Bulletin No.: PIC6376C

### PIC6376C A/C Evaporator TXV Tubes Bent

Brand:	Model:	Model Years:	VIN:		Engine:	Transmissions:
			from	to		
Chevrolet	Impala	2016 - 2020	All	All	All	All
Cadillac	XTS	2013 - 2019	All	All	All	All

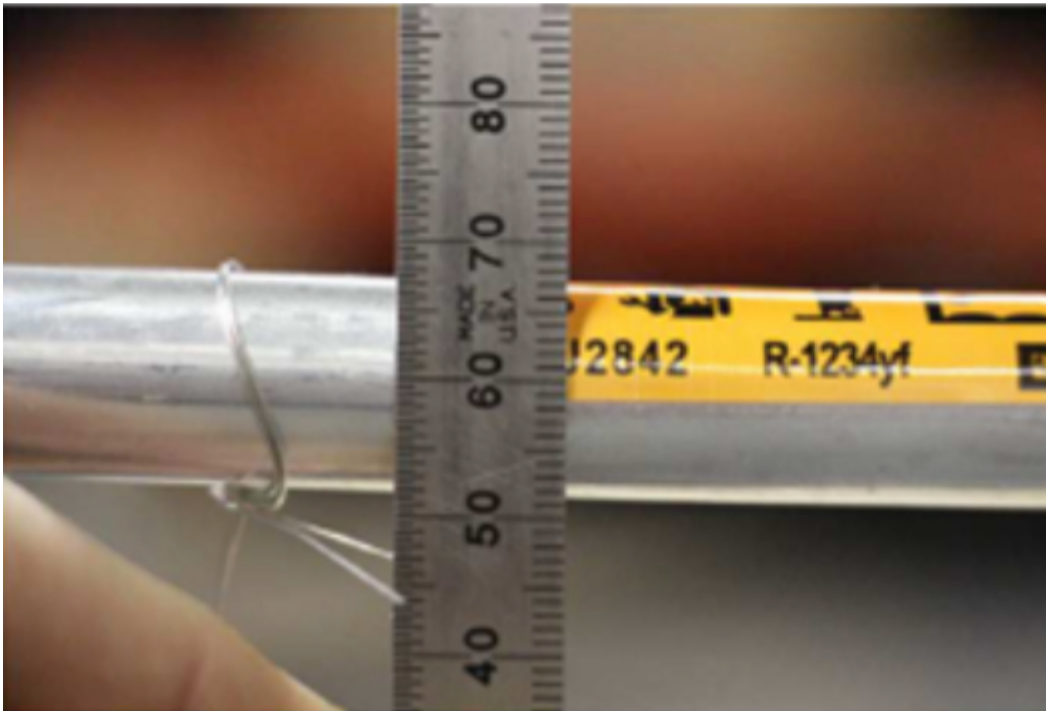
Inspect the new evaporator to see if the TXV tubes are bent at a downward angle as shown below.

If the TXV tubes on the new evaporator are bent down order a new evaporator and return the damaged part as "new defective". Do not attempt to adjust the tubes to allow installation of the evaporator in the HVAC case. If the tubes are bent or adjusted back into position this will result in a slow leak from the lock ring joint.

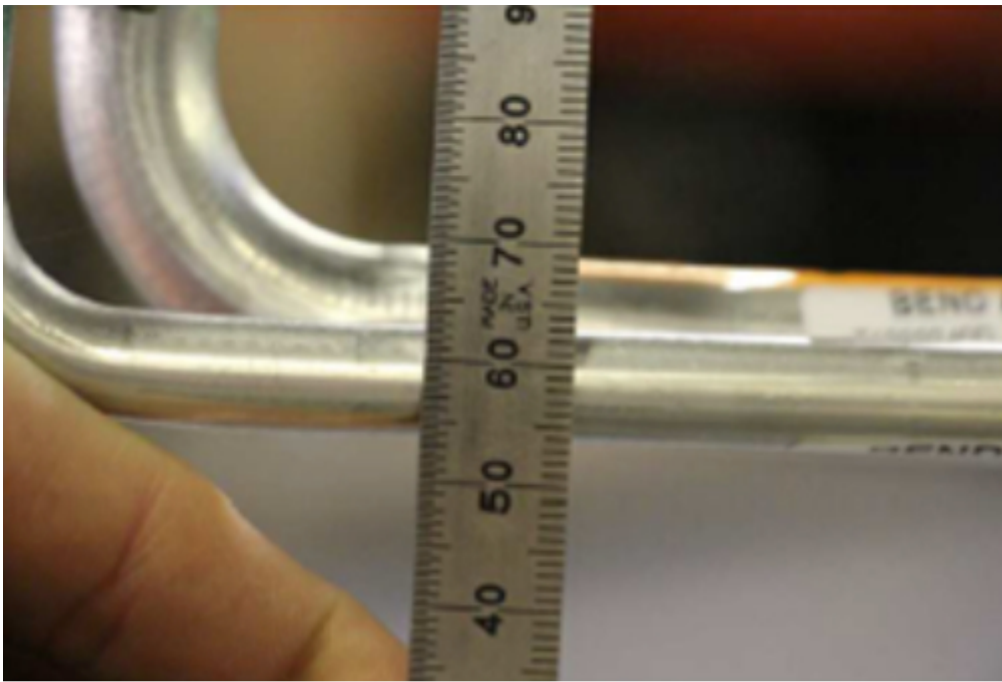
There should be a distance of 50-60 mm. when measuring from the core to the center of the TXV tubes as shown below.
